DETAILED ACTION

Response to Amendment

3. Claims 1-2 are rejected under 35 U.S.C. 103(a) as being unpatentable over Koike et al. in view of Yoshino et al. (US 5,190,794).

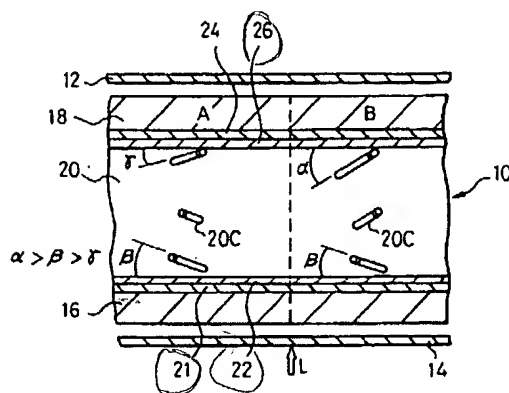
Below in Fig. 4, Koike et al. shows a circuit array substrate 18 having pixel electrodes 24, a counter substrate 16 (column 12, lines 1-2) having a common electrode 21, alignment films 22 and 26 formed on said pixel electrodes 24 and said common electrode 21, and a liquid crystal composition 20 charged in a gap between said circuit array substrate 18 and counter substrate 16 (column 11, lines 50-55).

While Koike et al. teaches that the color filter layer (not shown) is provided under the common electrode 21 (column 11, lines 65-70), Koike et al. also states that it is possible to reverse the common electrode 21 and the pixel (element) electrode 24 (column 12, lines 1-2). Therefore it would have been obvious to one of ordinary skill to have interposed the color filter under the pixel electrode 24 instead of common electrode 21, which places the color filter between the pixel electrode 24 and the circuit array substrate 18.

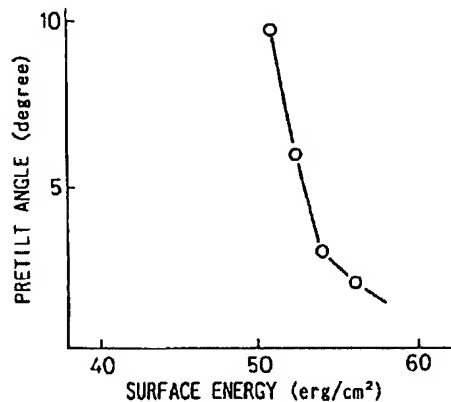
Koike et al. teaches that an increase in surface energy of the alignment films reduces the pretilt angle, and that this is done by taking advantage of UV irradiation of the polyimide film (column 16, lines 1-15). The polyimide film before irradiation has a higher pretilt angle with the corresponding lower surface energy (column 15, lines 55-65). Thus Koike et al. teaches

that low pretilt angle with the corresponding high surface energy for the alignment film is desirable.

The graph of pretilt angle versus surface energy above shows that the area of interest corresponding to the desired low tilt angle is the one with the surface energy of greater than 50 and less than 60 dyn/cm (erg/cm^2) which overlaps the claimed range of 51 to 60 dyn/cm. The prevention of image-sticking phenomenon and white or black turbid spots is the result of the low pretilt angle with the corresponding high surface energy of the alignment layer.
